From the Preamble:

Public Comment from Hans de Bruijn, 933 Mondale Road, Lancaster, PA 17601, Phone 717 392 1480 e-Mail; hdebruijn@comcast.net

Dear Mr. Van Wye and Mrs. Rebecca Stack;

Figure 9: diameters, Chart also settling vel

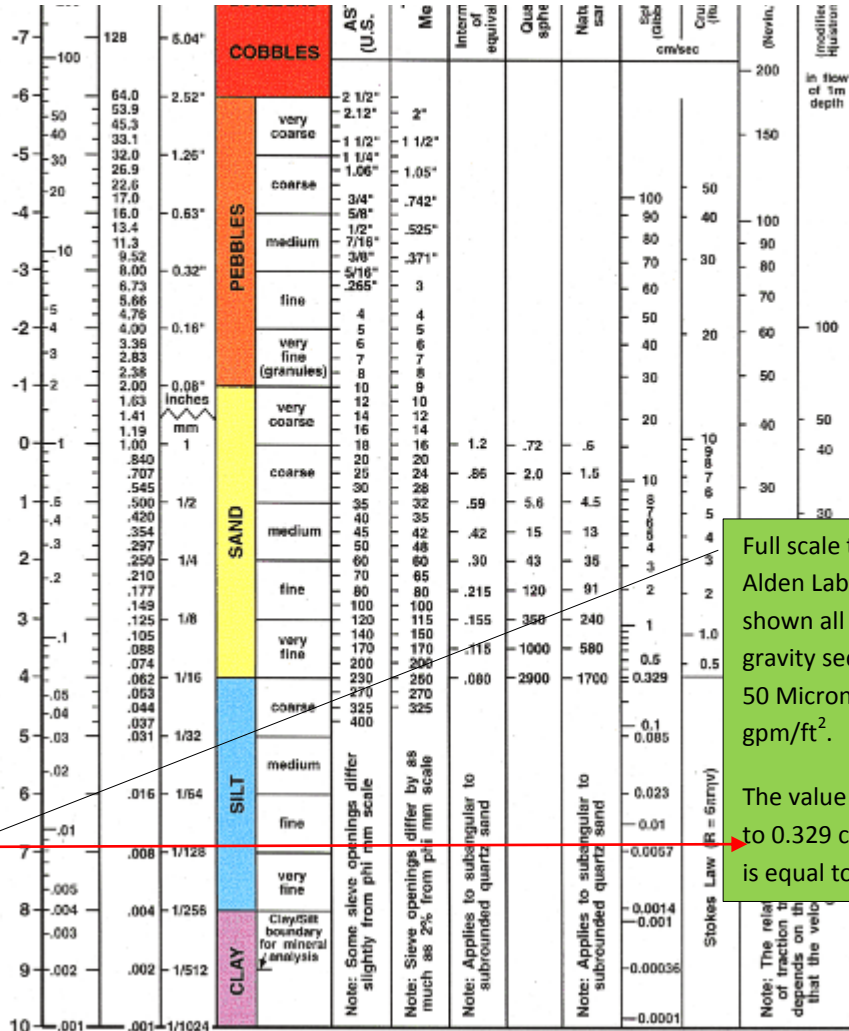
Full scale testing at Alden Laboratory has shown all 2.65 specific gravity sediment over 50 Microns settles at 10 gpm/ft².
The value is very close to 0.329 cm/sec which is equal to 12.3 gpm/ft²
